**PAUL VI CATHOLIC HIGH SCHOOL**

ISSUES AND REVISIONS		DATE
NO.	SUBMITTAL	
	PERMIT SET	01.31.17

**ROOF PLAN AREA A - MECHANICAL**

1 ROOF PLAN AREA A - MECHANICAL  
1/8" = 1'-0"

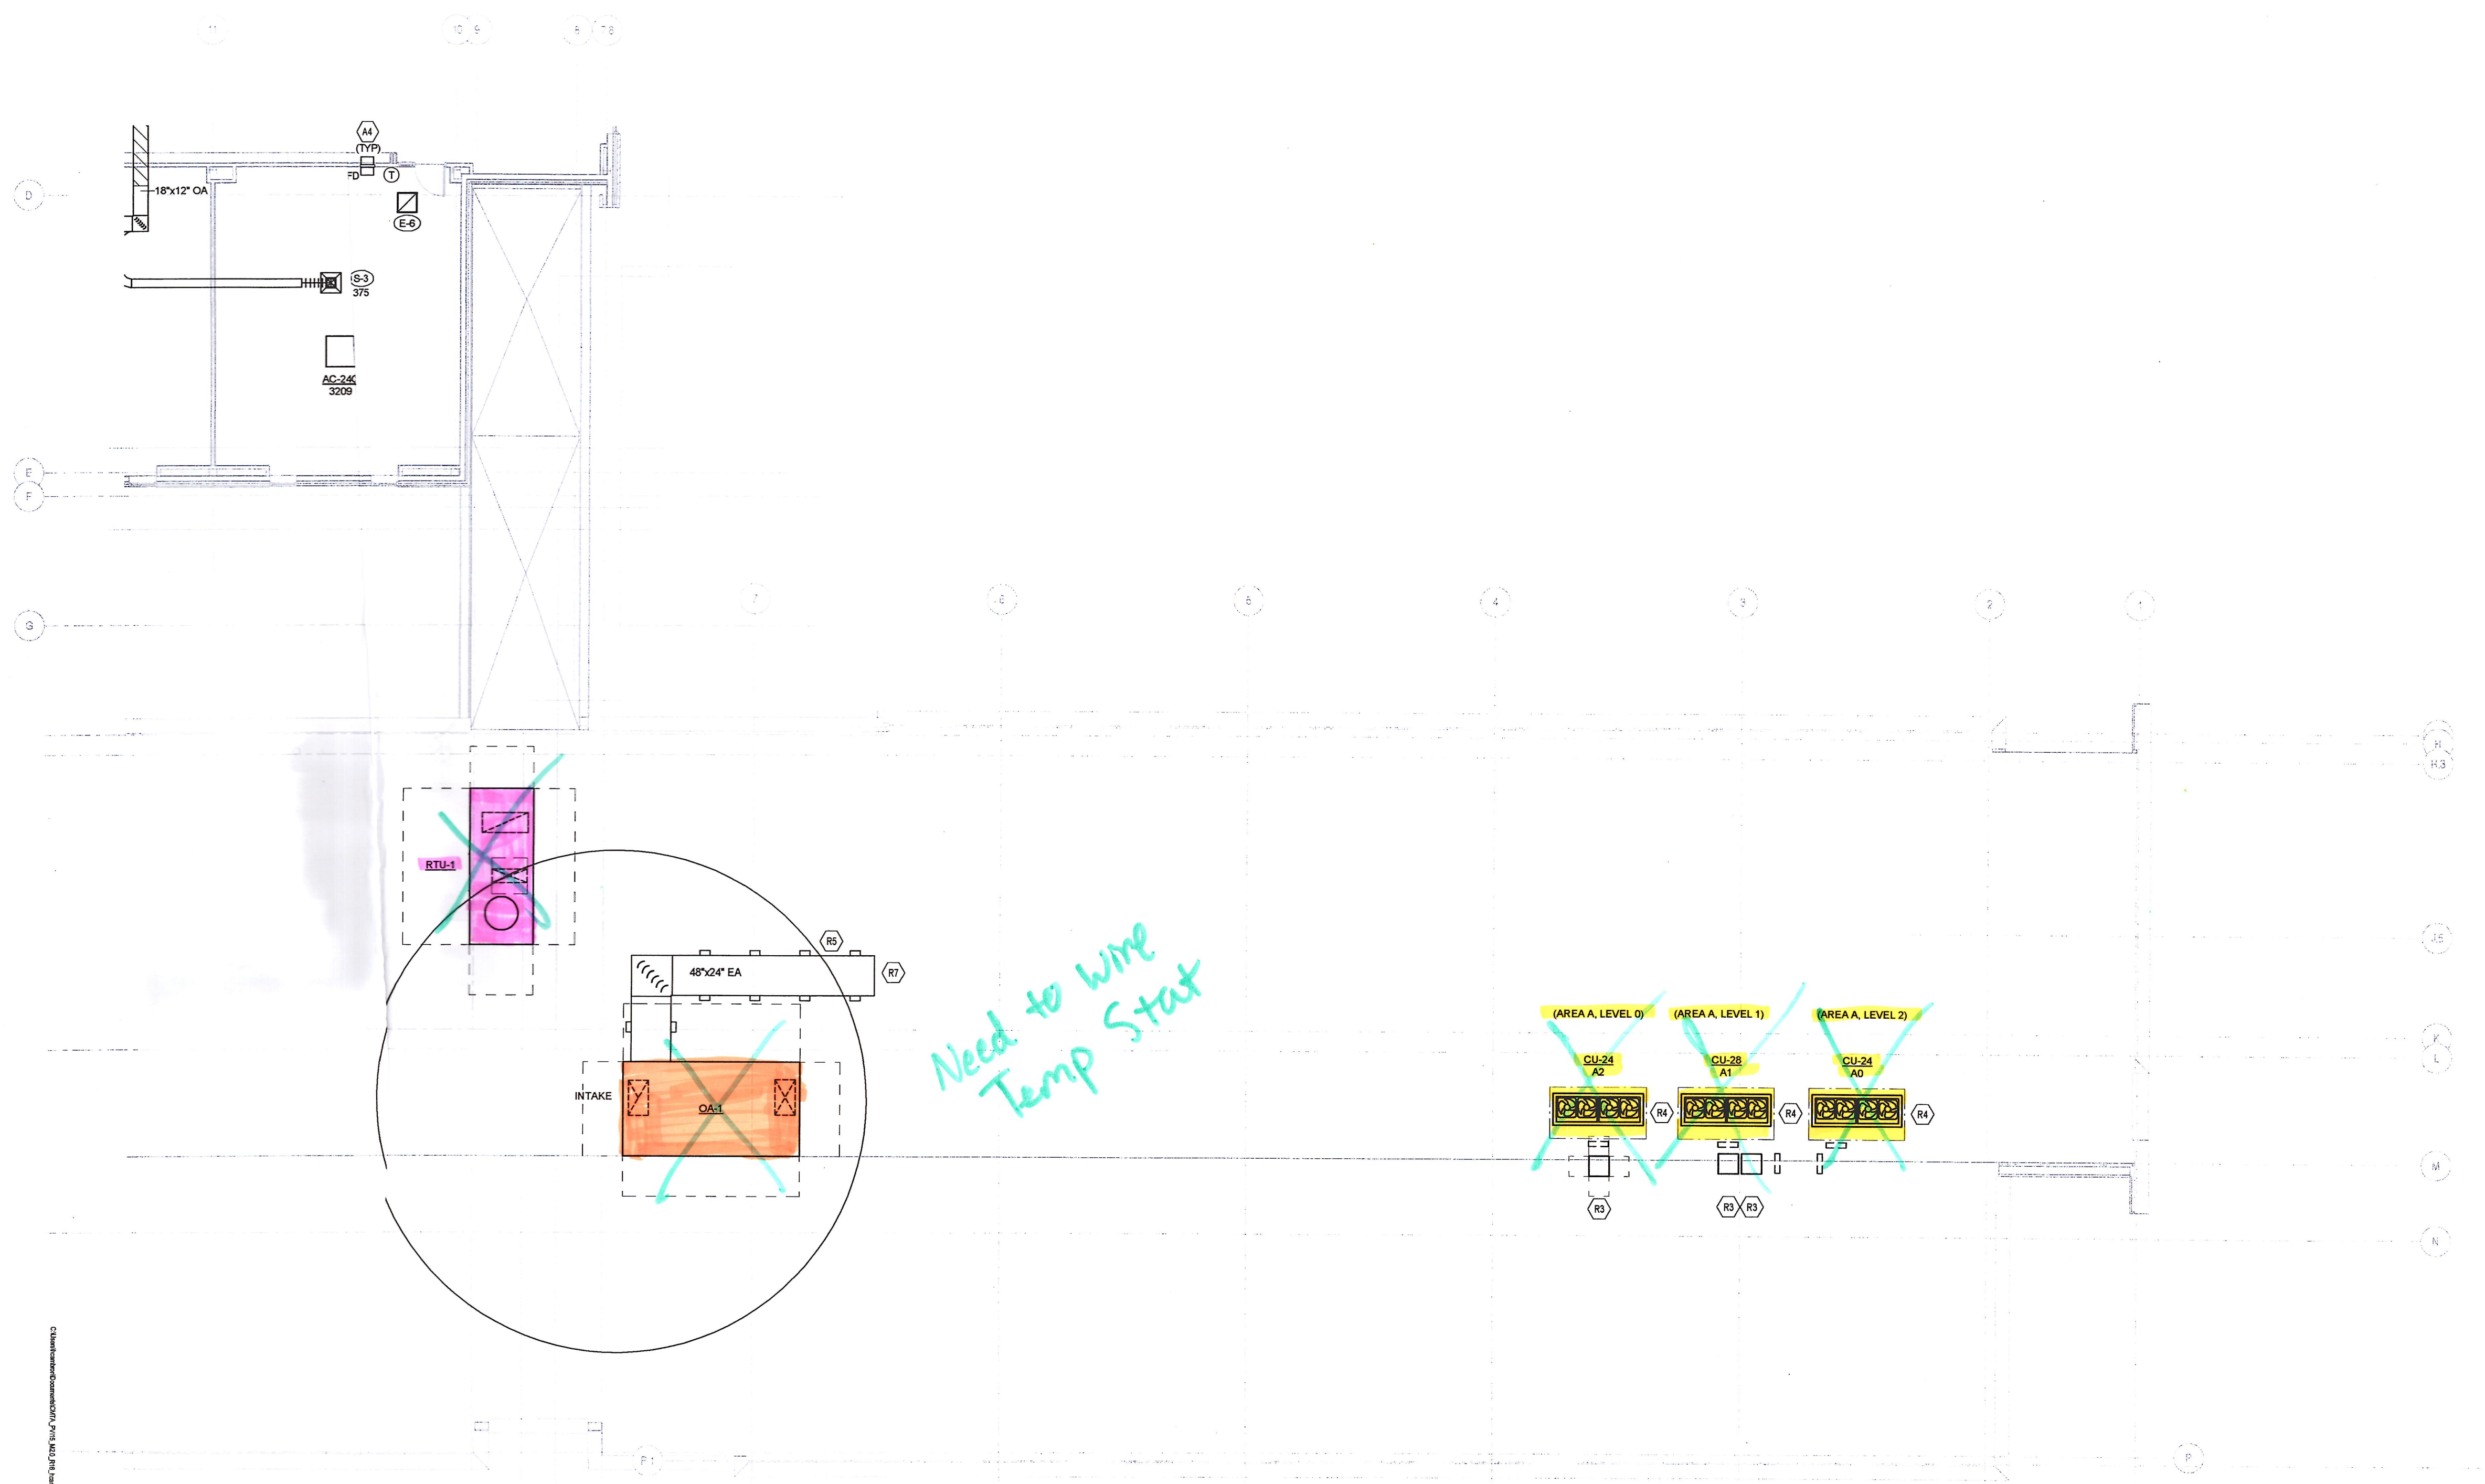
*Need to wire Temp Stat*
